**Economic and Social Council**Distr.: General
15 December 2022

Economic Commission for Europe**Inland Transport Committee****World Forum for Harmonization of Vehicle Regulations****189th session**

1958 Agreement:**Consideration of draft amendments to existing UN Regulations submitted by GRE****Proposal for Supplement 3 to the 08 series of amendments to
UN Regulation No. 48 (Installation of lighting and light-
signalling devices)****Submitted by the Working Party on Lighting and Light-Signalling***

Model A

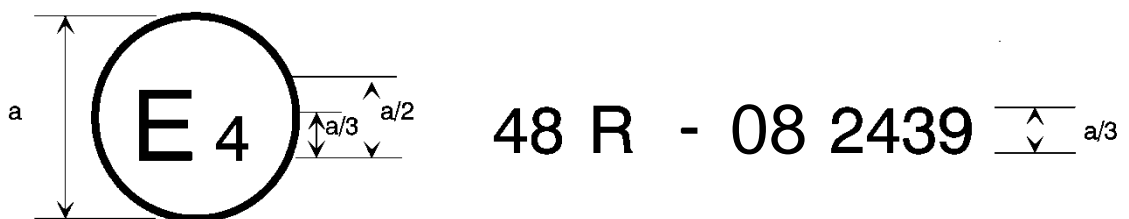
Annex 2, amend to read:

"Arrangements of approval marks

The above approval mark affixed to a vehicle shows that the vehicle type concerned has, with regard to the installation of lighting and light-signalling devices, been approved in the Netherlands (E4) pursuant to UN Regulation No. 48 as amended by the 08 series of amendments. The approval number indicates that the approval was granted in accordance with the requirements of UN Regulation No. 48 as amended by the 08 series of amendments.
